#### **Addendum 89 – UN Regulation No. 90**

#### **Revision 3 - Amendment 6**

Supplement 6 to the 02 series of amendments – Date of entry into force: 25 September 2020

#### **Uniform provisions concerning the approval of replacement brake lining assemblies, drum-brake linings and discs and drums for power-driven vehicles and their trailers**

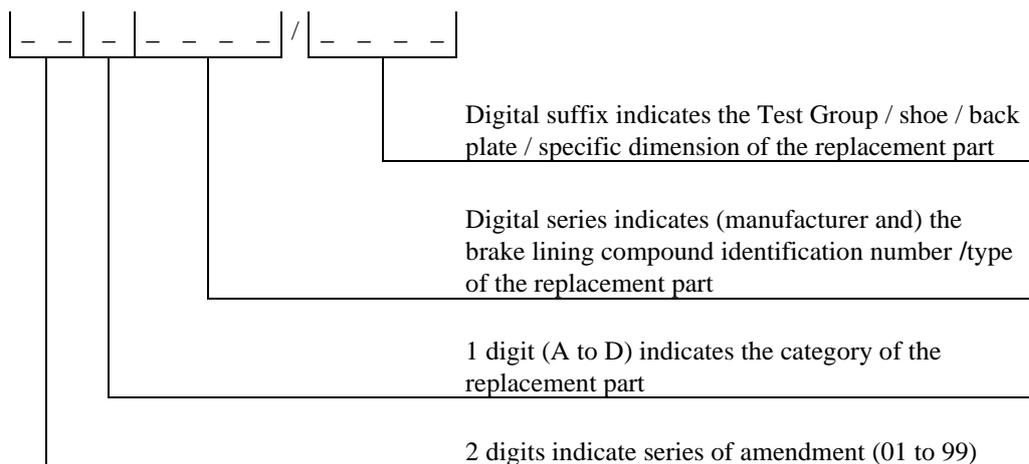
Paragraph 4., amend to read:

4.2. To each replacement part approved there shall be assigned an approval code and an approval number, the latter in the format according to Schedule 4 to the Revision 3 of the 1958 Agreement. The approval code shall comprise four groups of digits:

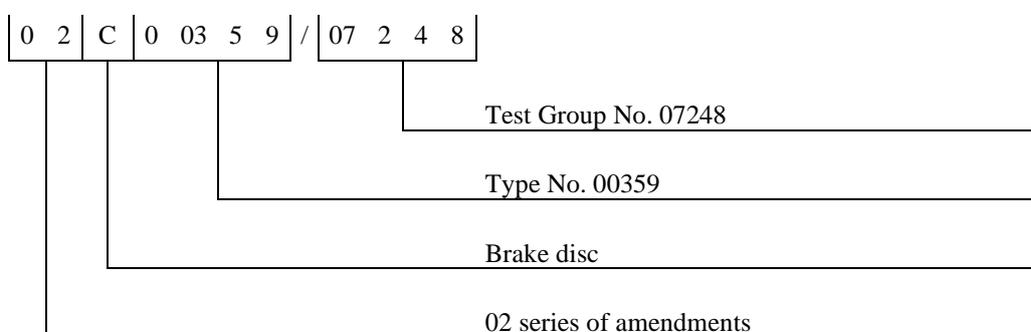
4.2.3. The next series of digits shall indicate the manufacture and the brake lining compound identification number of the brake lining, the type of disc or the type of drum.

The digital suffix shall indicate:

- (a) The shoe or back plate or specific dimension in the case of drum brake linings;
- (b) The Test Group in the case of a replacement disc or replacement drum.

The variants approved as a Test Group shall be listed as an appendix to the communication document:

Example:
